**Re: GE-Pittsfield/Housatonic River Site  
Floodplain Residential and Non-Residential Properties Adjacent to 1 ½ Mile  
Reach of Housatonic River (GECD710 and GECD720)  
Work Plan Addendum – Phase 1, Group 1A and 1B Properties**

This letter constitutes the required Addendum for the Phase 1, Group 1A and 1B properties. It addresses the conditions in EPA's conditional approval letter that relate to these properties and also includes some additional clarifications and updates pertaining to those conditions and the properties in question. In addition, it presents a proposed schedule for the initial pre-design investigations at these properties.

**FLOODPLAIN PROPERTIES-  
 1 1/2 MILE REACH - PHASE 1,  
 GROUPS 1A AND 1B**

FIGURE  
**1-1**

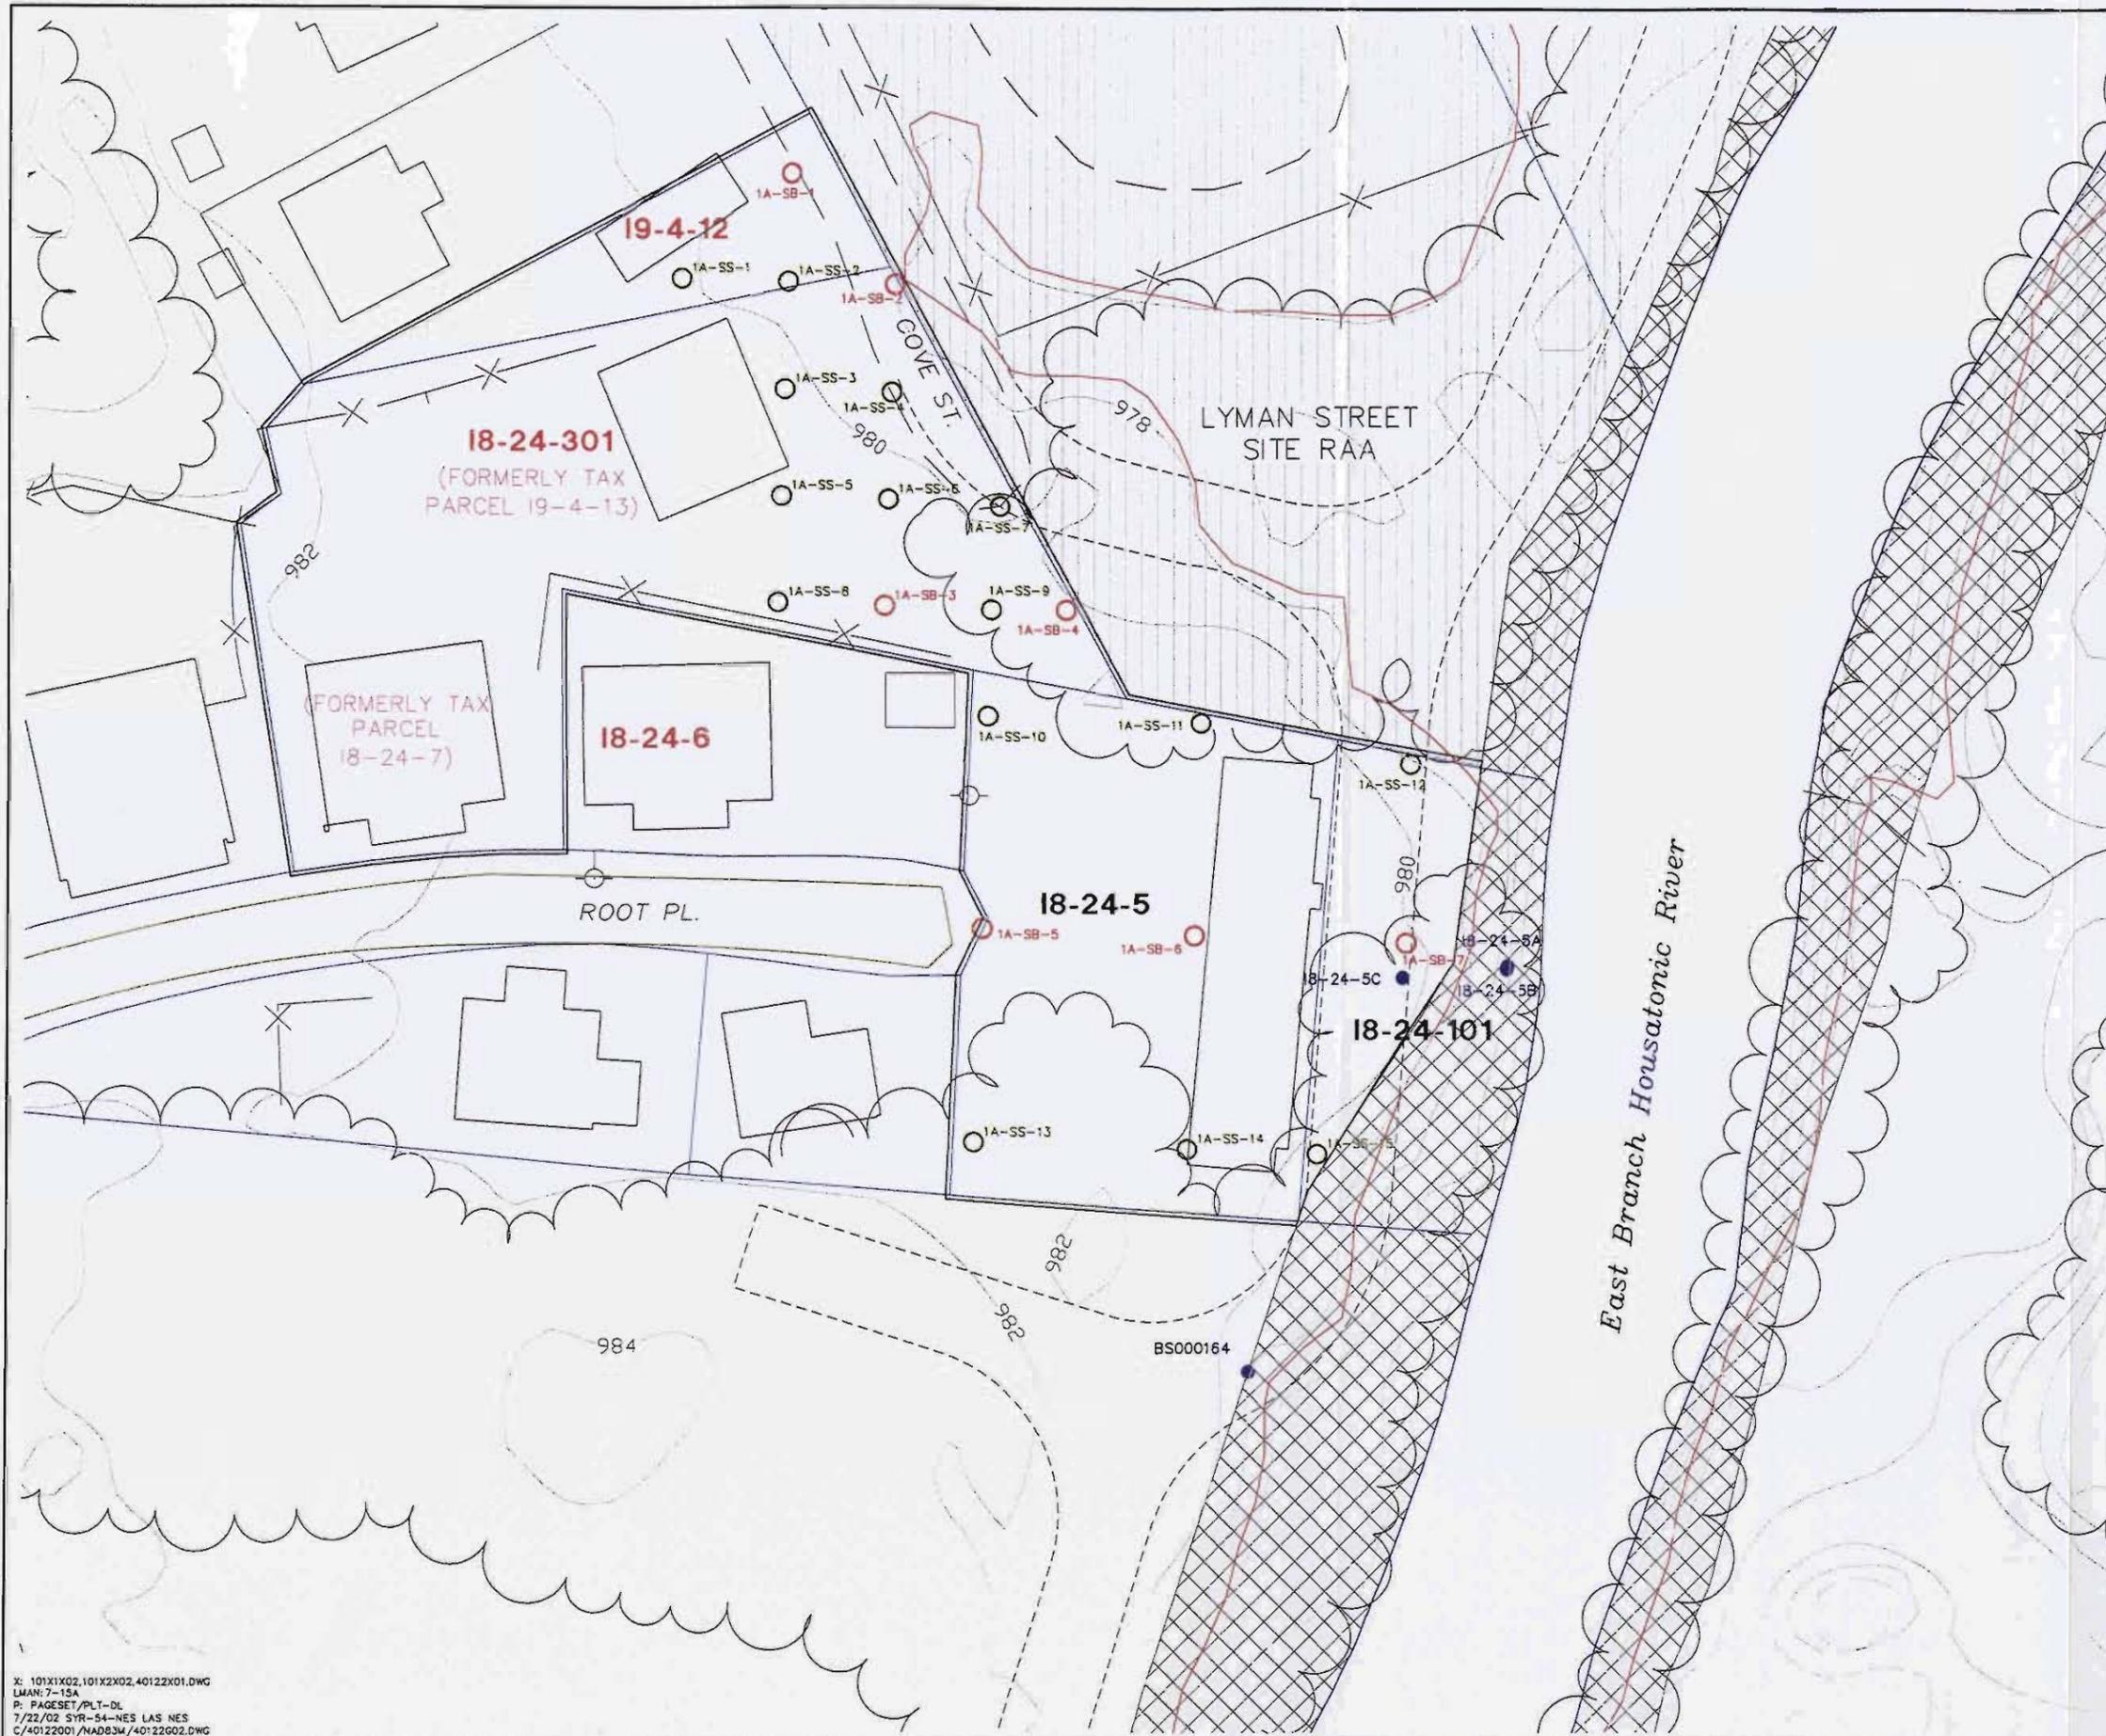
1. EPA Specific Condition No. 1 for the Phase 1, Group 1A and 1B properties states that Parcel I8-24-6 and Parcel I9-4-13 were recently combined into Parcel I8-24-301 for tax purposes and that, as such, additional pre-design sample locations should be identified in the Addendum (for Parcel I8-24-6). However, based on review of the City of Pittsfield Tax Assessors' Records, GE has determined that it was Parcel I8-24-7 (rather than Parcel I8-24-6) that has been combined with Parcel I9-4-13 to form Parcel I8-24-301. GE has revised Figures 1-1 and 4-1 to identify the new boundary of Parcel I8-24-301.

2. GE has revised Figure 1-1 (which depicts the Phase 1, Group 1A and 1B properties) and Figures 4-1 and 4-2 (which depict existing and proposed PCB sampling locations for the subject properties) to include the 10-year floodplain boundary and the available topographic contour lines. In addition, Figure 1-1 and 4-1 have been revised to indicate a change in the designated land use for Parcel I9-4-12. The SOW, and more recently the PDI Work Plan, had identified this parcel as a non-residential/non-commercial property. However, a recent reconnaissance performed by GE identified this parcel as a residential property. Based on a review of the proposed initial soil investigations, this change in property use designation does not warrant a modification to the initial pre-design sampling locations, since the spacing of the proposed sample locations on this parcel is generally consistent with those at the adjacent residential property (now Parcel I8-24-301). However, samples from the proposed soil boring on Parcel I9-4-12 will be collected from depth increments consistent with those identified for residential properties in the PDI Work Plan (i.e., 0 to 1 foot, 1 to 3 feet, 3 to 5 feet, 5 to 7 feet, and 7 to 9 feet).
